FINAL DRAINAGE REPORT – ADDENDUM NO. 1

**ARACO ENTERPRISES LLC - BUILDING ADDITION
7470 SOUTHMOOR DRIVE, FOUNTAIN, CO**

**JPS Project No. 111705
PPR-1950**

DEVELOPED DRAINAGE PLAN

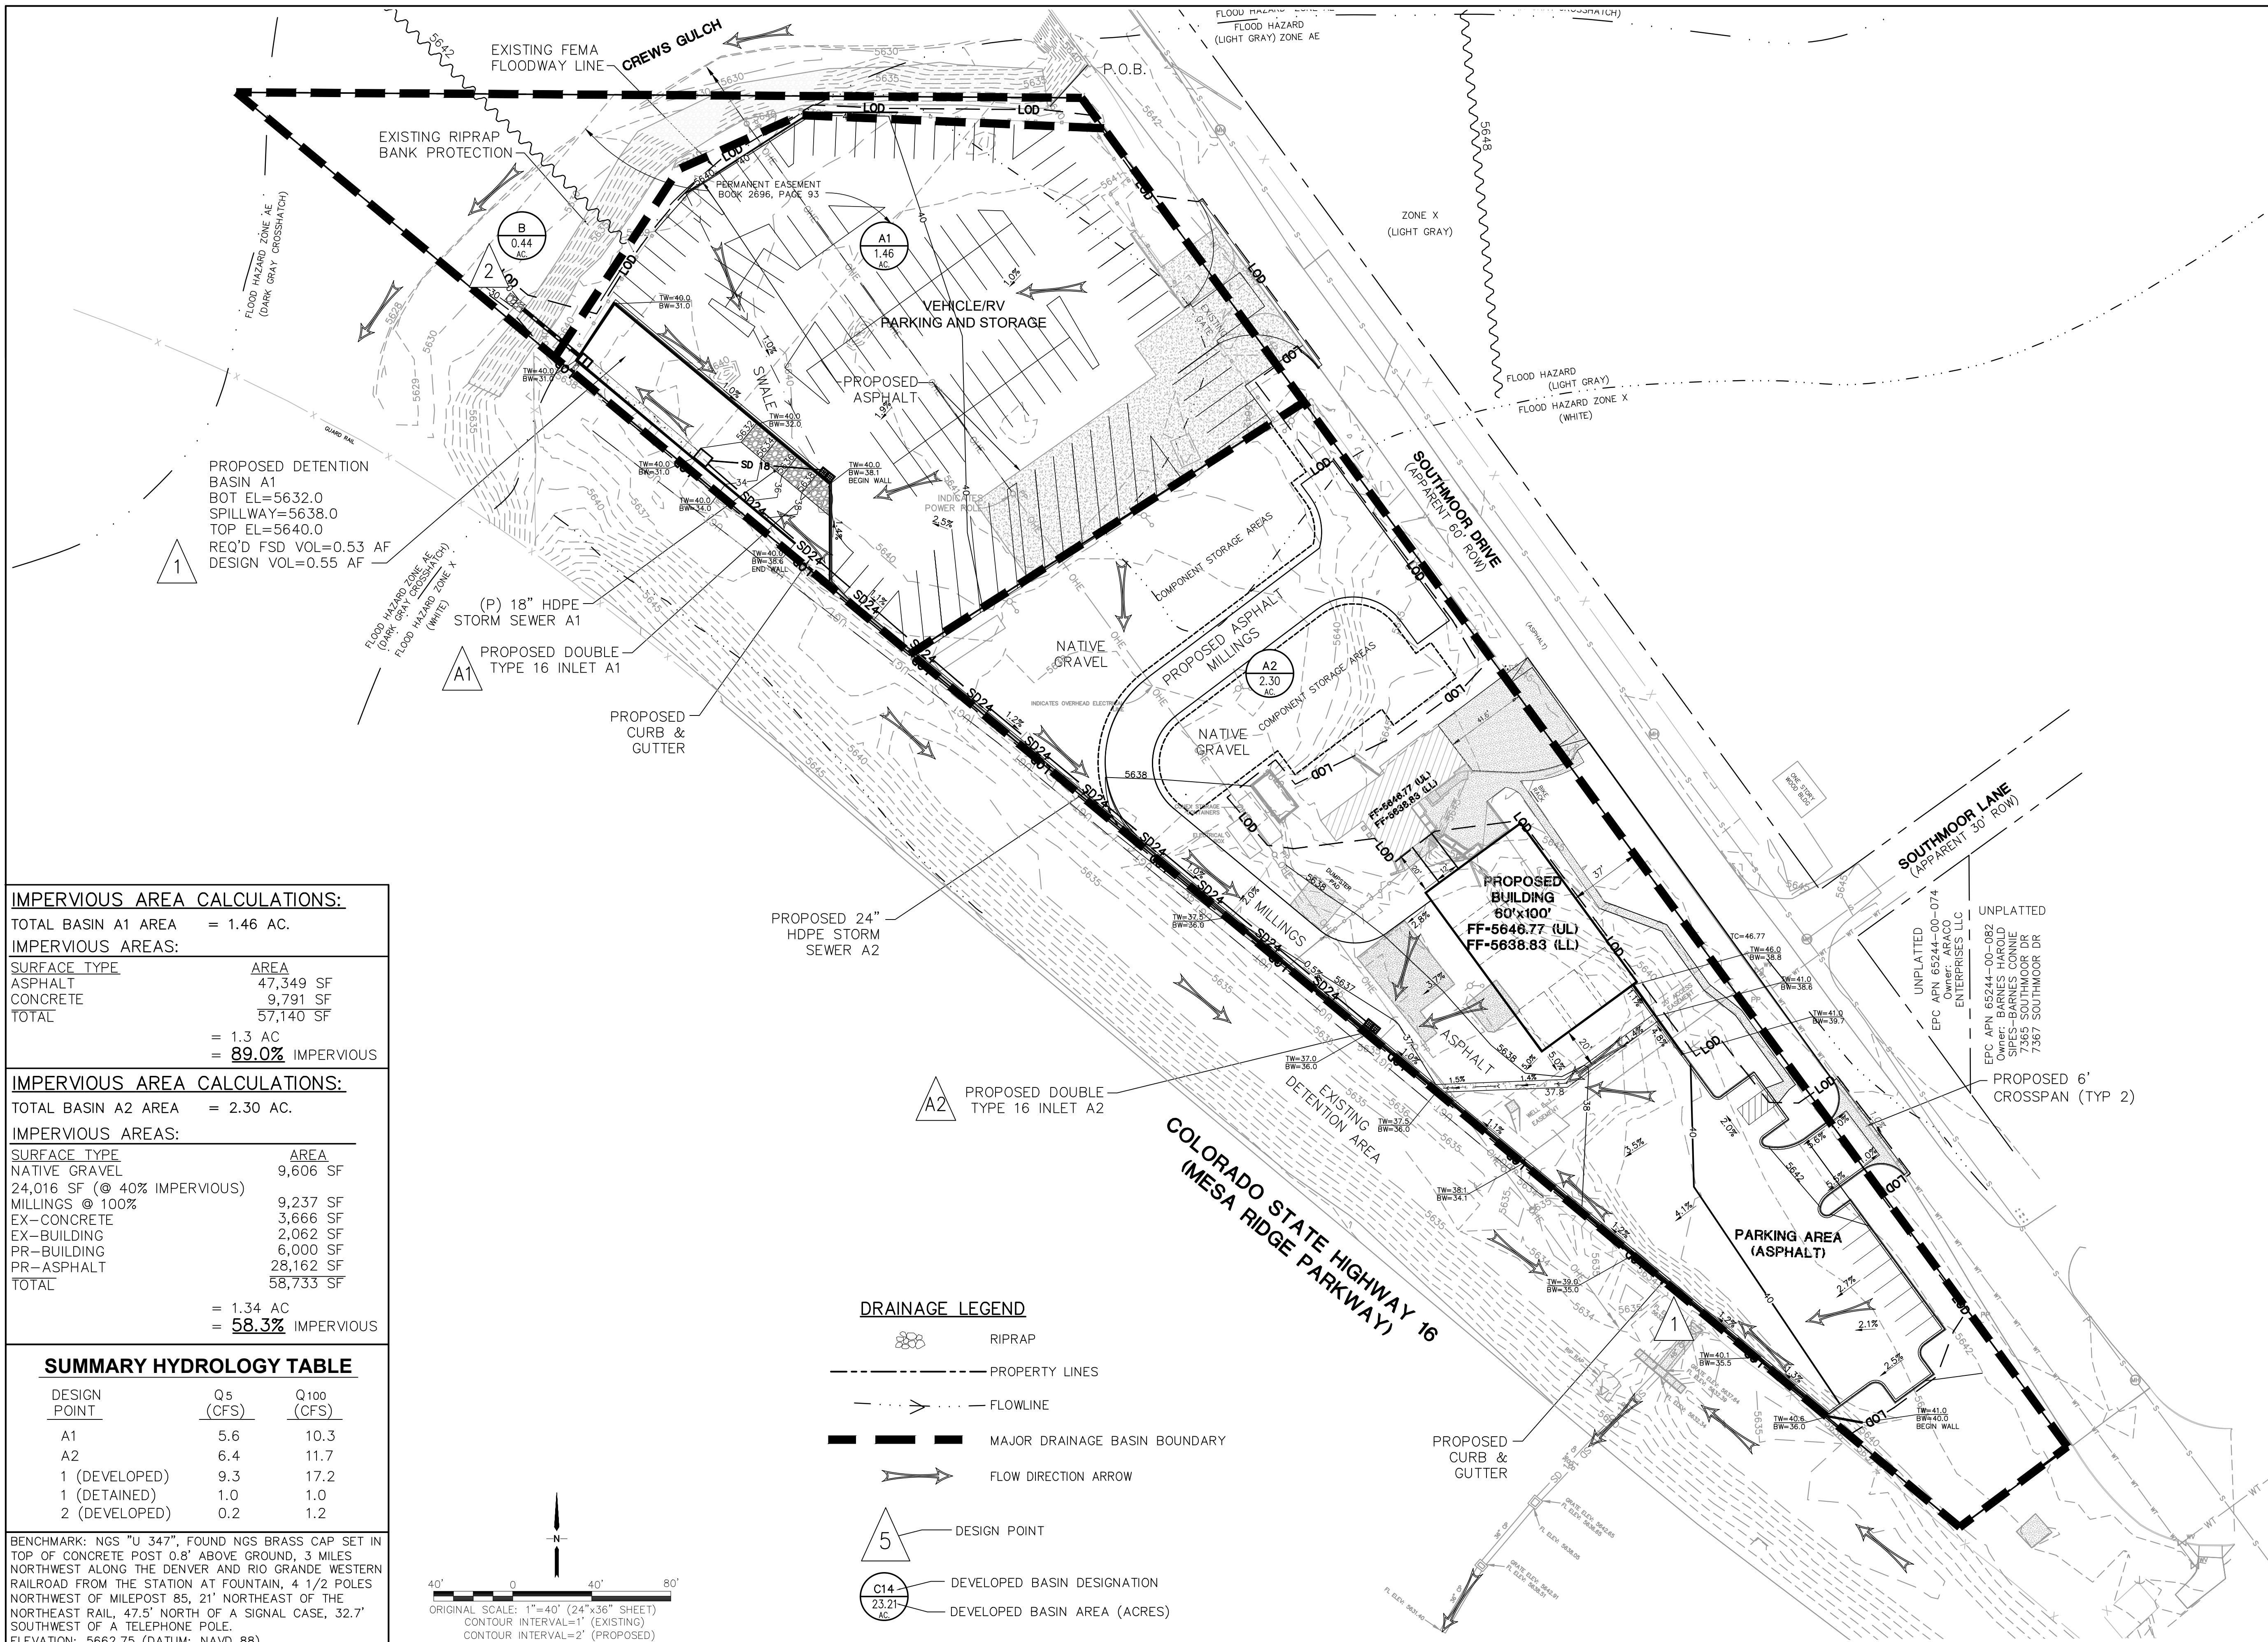
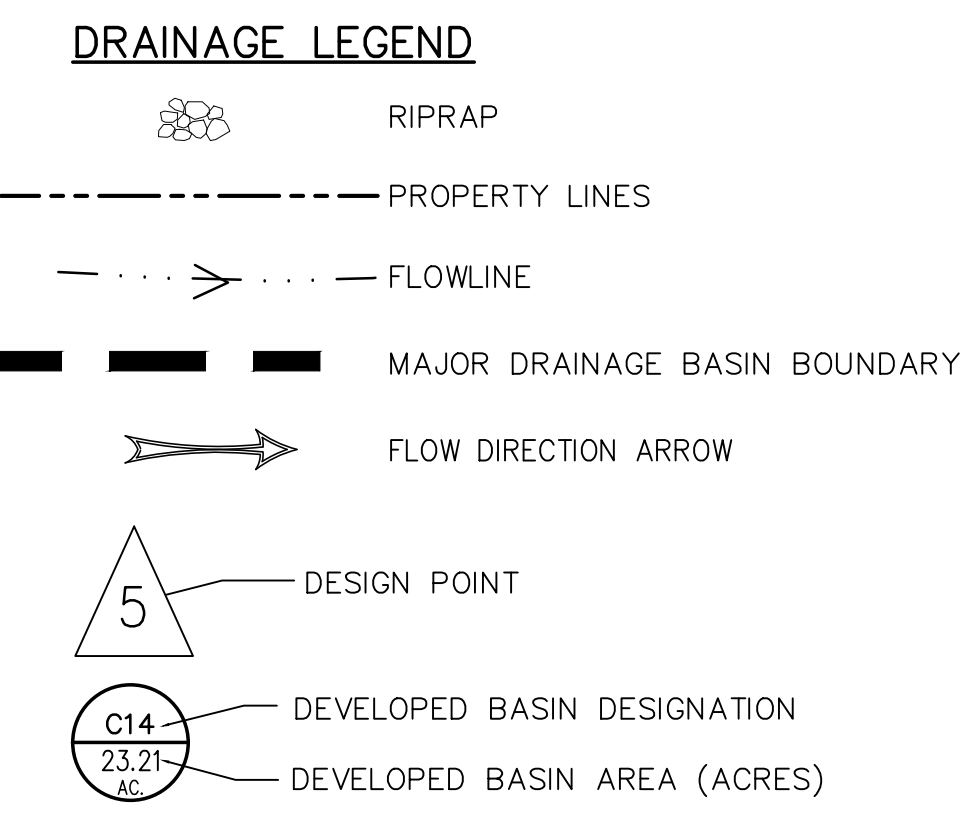
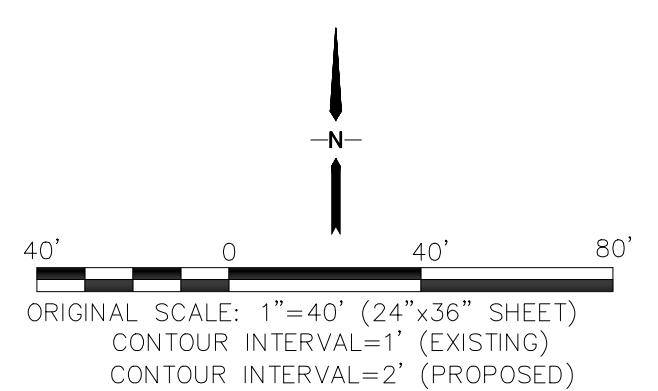
The developed drainage basins and projected flows are shown on the attached Figure D1 (Appendix C). The previously depicted Detention Basin A2 (near the southeast corner of the site) has been eliminated, and the proposed Detention Basin A1 at the northwest corner of the site has been enlarged to meet all of the required on-site stormwater detention and water quality requirements.

PROPOSED DETENTION BASIN A1
 BOT EL=5632.0
 SPILLWAY=5638.0
 TOP EL=5640.0
 REQ'D FSD VOL=0.53 AF
 DESIGN VOL=0.55 AF
